PROPOSED TECHNICAL  
SPECIFICATION CHANGES

**DISCUSSION AND  
SIGNIFICANT HAZARDS  
CONSIDERATION EVALUATION**

**TECHNICAL SPECIFICATION CHANGE REQUEST**  
**SURRY POWER STATION - UNITS 1 AND 2**  
**24-HOUR SERVICE WATER ACTION STATEMENT**  
**TEMPORARY SERVICE WATER SUPPLY LINE**

FIGURE 7 - SYSTEM CONFIGURATION FOR STEP 10

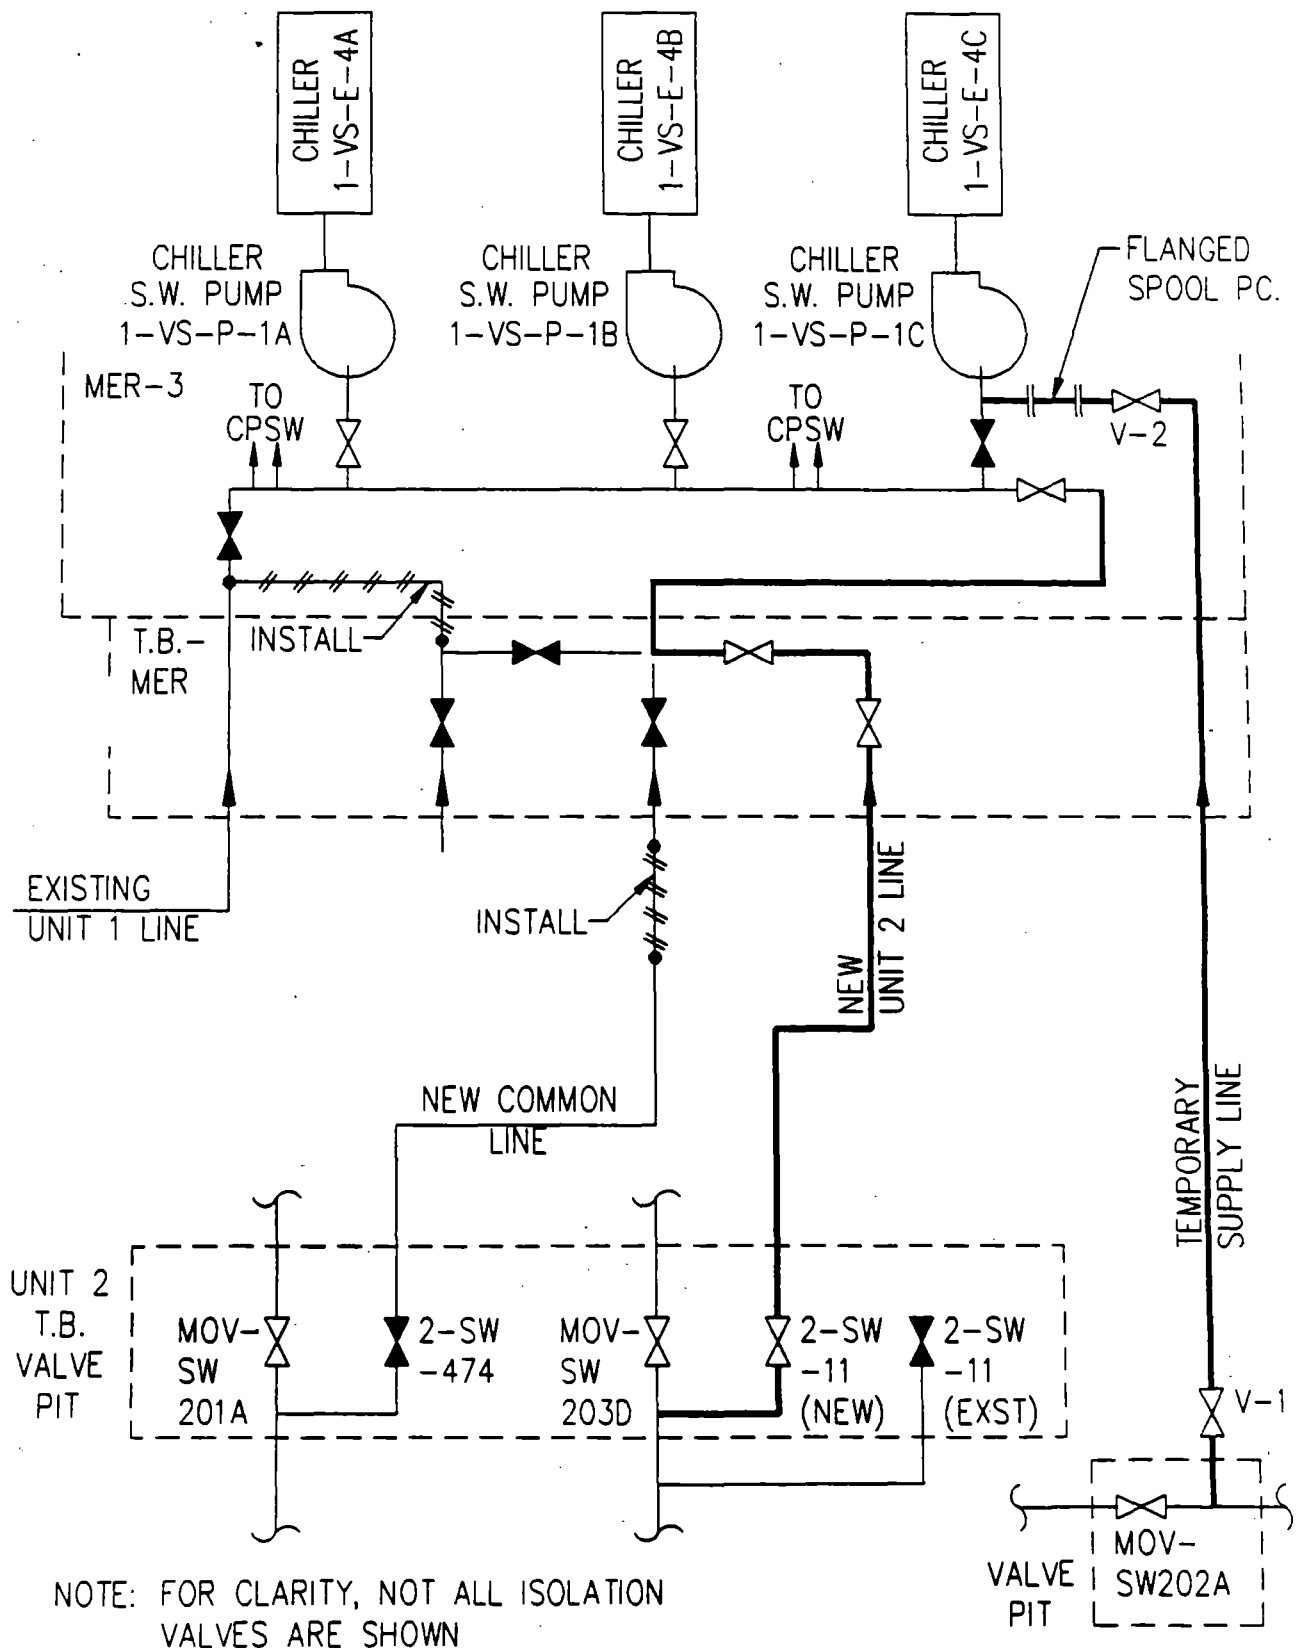
9. Replace the temporary jumper of step 6 with permanent 8" Cu-Ni piping. Complete installation of new 8" common line.
10. Remove the existing Unit 1 line from service and enter 24-hour action statement. Make the permanent Cu-Ni tie-in for the Unit 1 line in the TB-MER 3 room. At this point, two new independent flow paths exist. Both originate in the Unit 2 SW valve pit from separate sources, travel in separate lines and supply the MER-3 components. Exit the 24-hour action statement.
11. Install the permanent Unit 1 8-inch line without any impact on system operation i.e., installation of the new Unit 1 line will not require use of the 24-hour action statement.
12. During the next Unit 2 refueling outage, stop-log screenwell 2A and permanently remove the original 6-inch Unit 2 supply valve (2-SW-11) and upstream piping in the Unit 2 SW valve pit.
